# MSO9104A-03

# S E R V I C E N O T E

## MSO9104A - 1GHz Mixed Signal Oscilloscope

### Repair for Windows "Power surge on hub" message

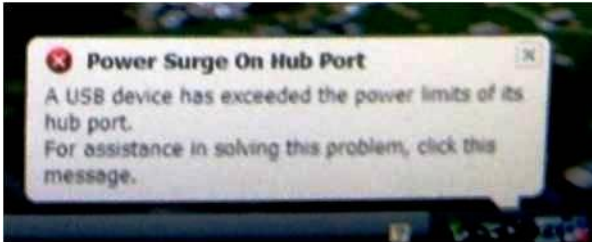
A few scopes display the below message. This upgrade kit installs three components which will resolve the problem and the message should disappear. If the message still appears, either the upgrade was done incorrectly or the motherboard is actually defective.

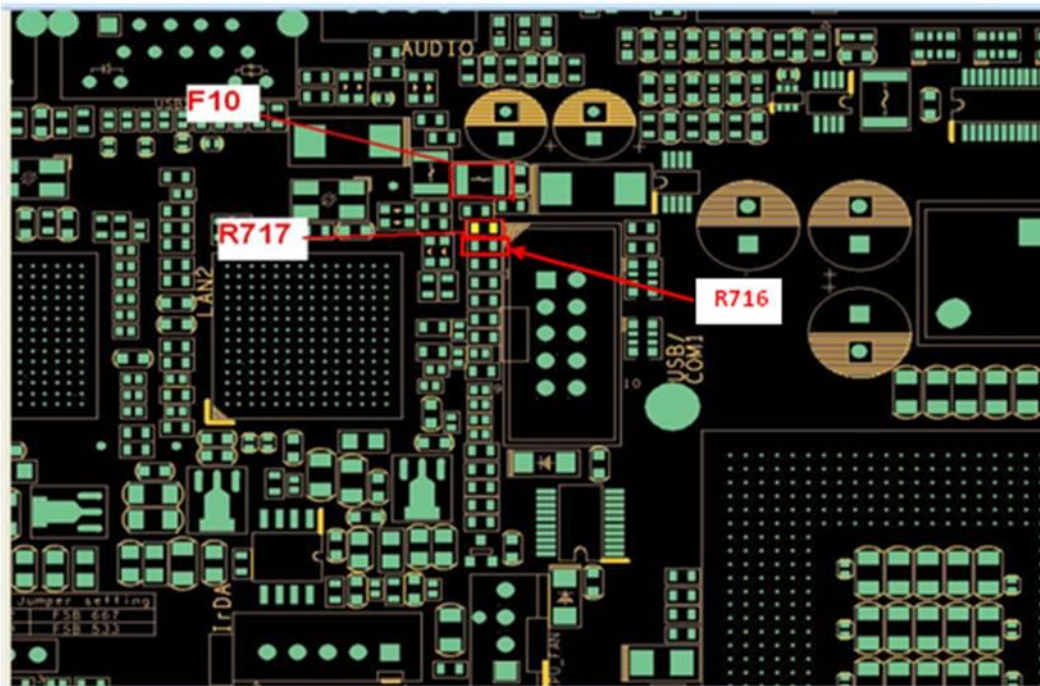
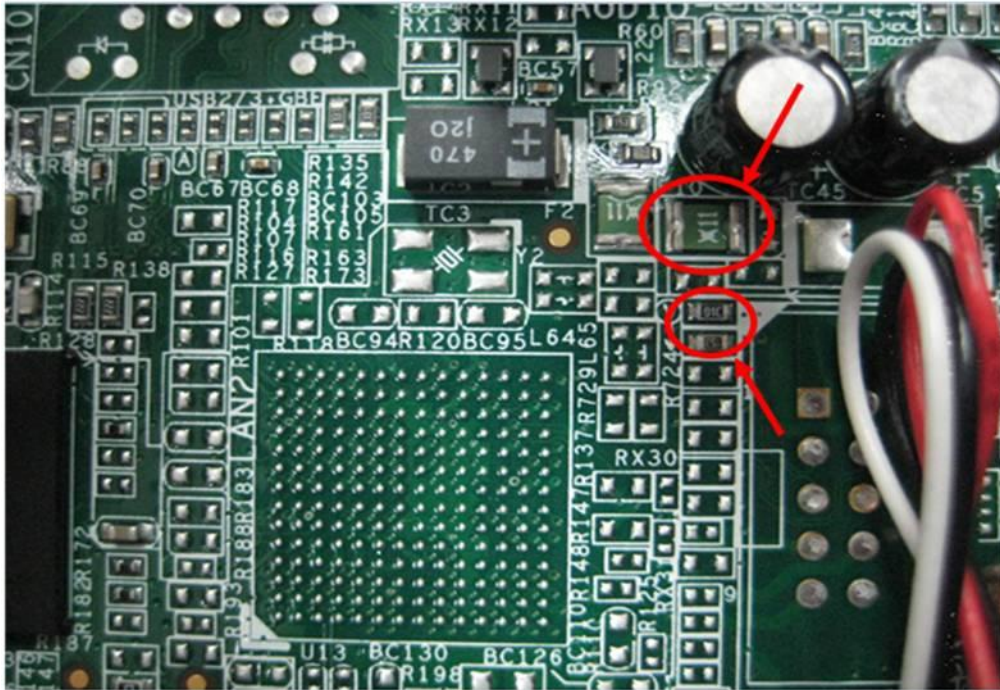
F10 – 0837-3854 Thermistor

R717 – 0699-7654 10K Resistor

R716 – 0699-5789 15K resistor

1. Refer to the service manual to remove the motherboard from the scope.
2. Install the three components from the upgrade kit on the motherboard. Refer to the below drawing and the drawing on the next page for component locations. The 0960-2789 motherboard is RoHS compliant and the below three components are also RoHS compliant. You should use a RoHS soldering station and RoHS solder techniques when possible.
